September 4, 2020

Subject: Engineering Response to Comments Letter
Board of Zoning Appeals Case No. 3416
The Overlook - 44 Wharf Street, Weymouth, Massachusetts
CEC Project 193-187

KD's, DPW's and CONCOM's comments are summarized below in italics, followed by CEC's responses.

C500
SHEET 6 OF 12

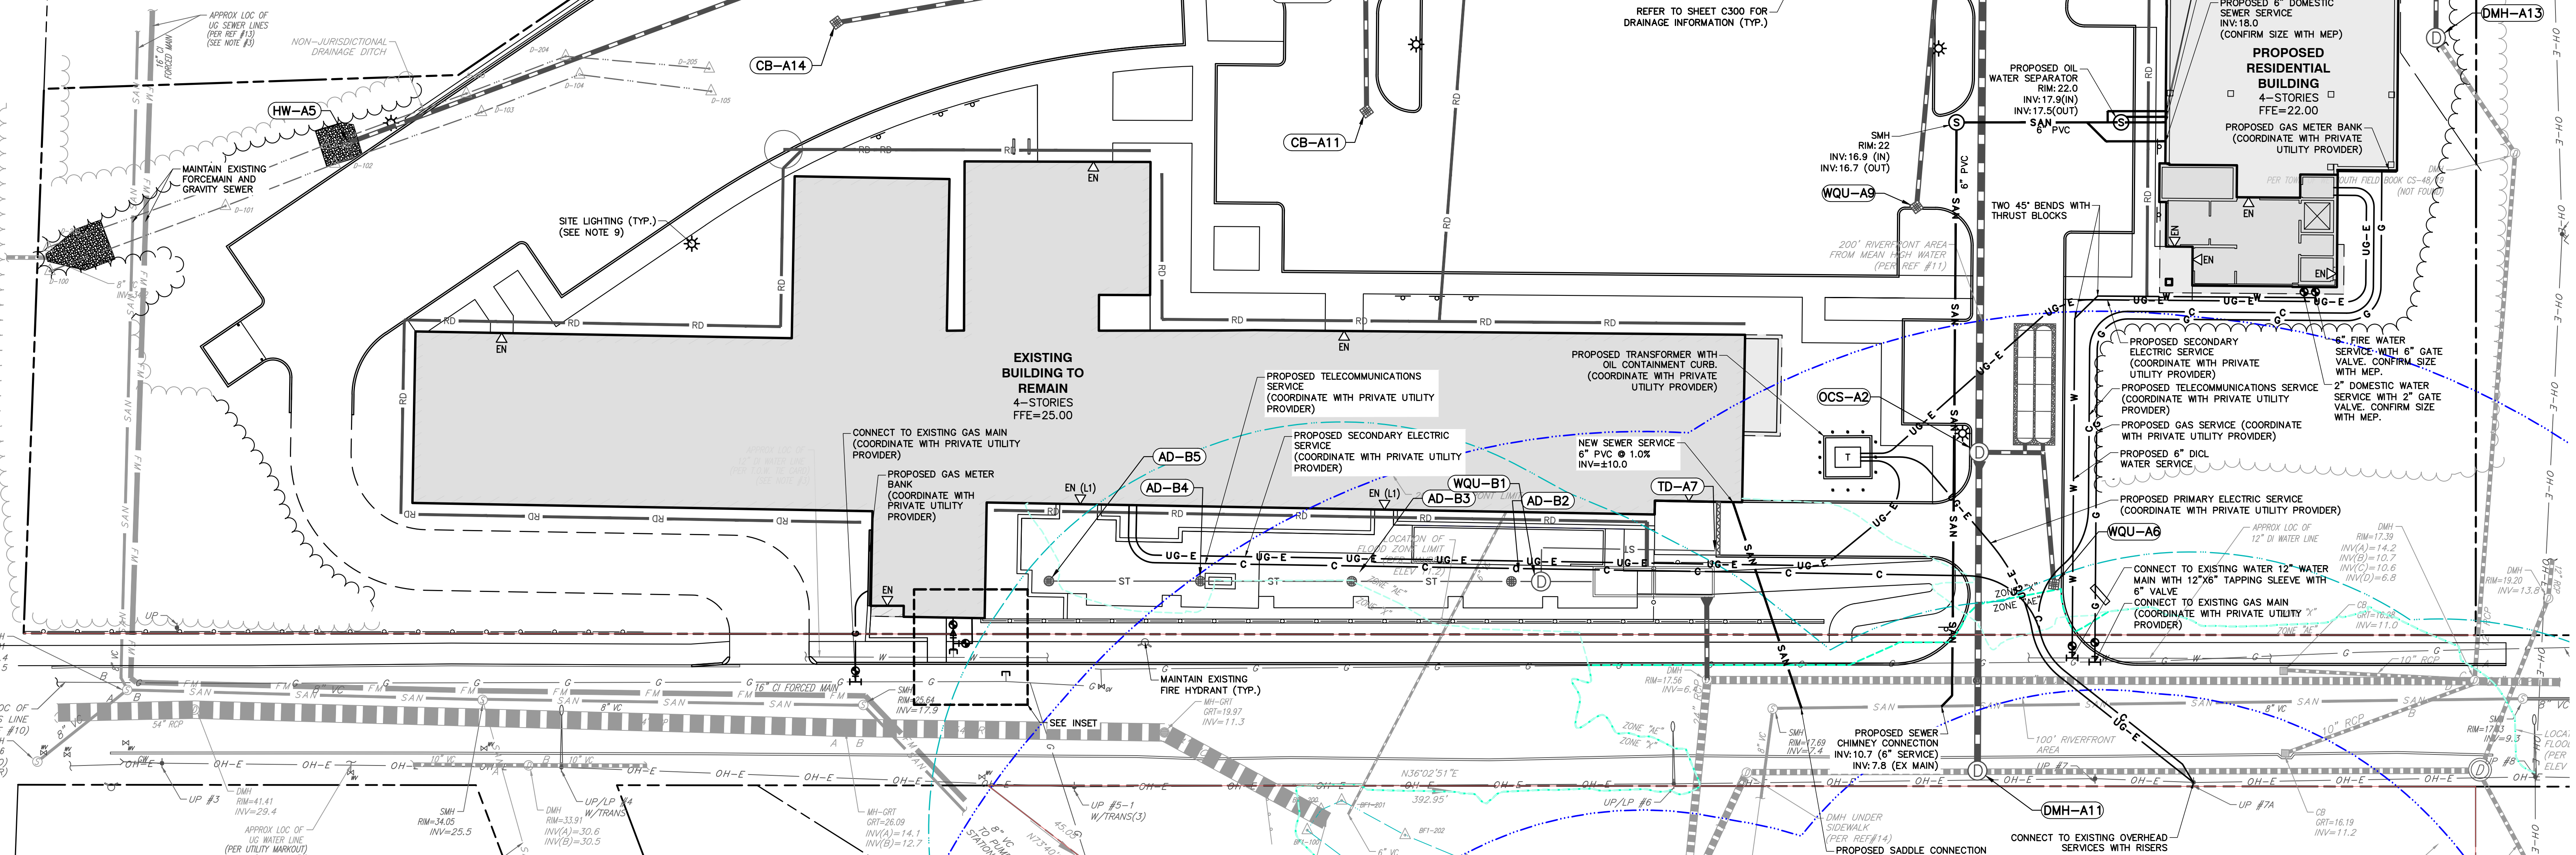
5. DPW: *Water Services for Existing Building to Remain — Connect to the existing 12" x 8" tap, add an 8" x 4" tee with valve for domestic, reduce 8" nipple to 6" with reducer and add 6" gate valve for fire line to eliminate the need for 2 new taps.*

6. DPW: *Water Services for Proposed Residential Building — Connect to 12" main with a 12" x 8" tapping sleeve & valve, run an 8" main to the building, cut in a 2" line with valve for domestic, add 8" x 6" reducer with 6" valve to isolate fire line. Provide a yard/blow-off hydrant at the end of the new 8" main.*

CEC Response: Noted. The Plans have been revised to include a new sewer service to the Mill Building and the existing sewer service to the Mill Building will be cut and capped at the main and replaced with a new service with saddle connection.

CEC Response: Noted. The old water service to the meter pit is shown to be cut, capped, and abandoned at the main. The existing 8-inch service to the building will be maintained per DPW Comment 5 below.

CEC Response: The water service design has been revised as requested. Refer to the revised Utility Plans for the updated water service configuration.

CEC Response: Refer to the revised Utility Plans for the updated water service configuration.
